**STAFF REPORT:** 10/12/2022 REGULAR MEETING

**ADDRESS:** 4001 14<sup>TH</sup> STREET

**APPLICATION NO:** #2022-8052

**SCOPE:** DEMOLISH EXISTING FRONT STEPS, CONSTRUCT NEW FRONT STEPS

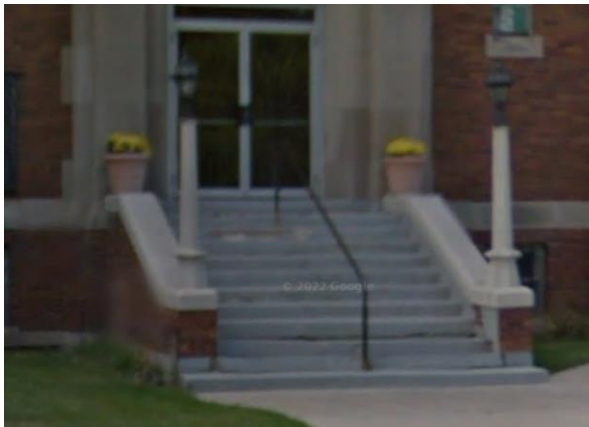
- The current cementitious coating was present at the time of the district’s designation in 2020.
- A review of Google Streetview images revealed that the cementitious coating was applied as a means to patch cracks/deterioration at the steps between 2007 and 2009. It appears that the coating was routinely added/added to over the over the years in order to temporarily address deterioration/patch holes and cracks as they materialized.

- As previously noted, the stone steps were covered with the current cementitious coating and paint at the time of the district's designation. It is also staff's opinion that the stone steps appear to be in an advanced state of deterioration and the cost of any possible repair would not be financially feasible. As such, it is staff's opinion that the submitted proposal is a compatible, financially- feasible option and does meet the SOI Standards as an appropriately stained concrete would adequately match an historic stone step.

- HDC staff shall be afforded the opportunity to review and approve the style, location, and height of the porch handrail prior to the issuance of the project's permit
- The new concrete cannot be "bright white". Rather, it shall be tinted a color which matches the stone trim/detailing found at the building's exterior walls. HDC staff shall be afforded the opportunity to review and approve the color of the tint prior to the issuance of the project's permit.
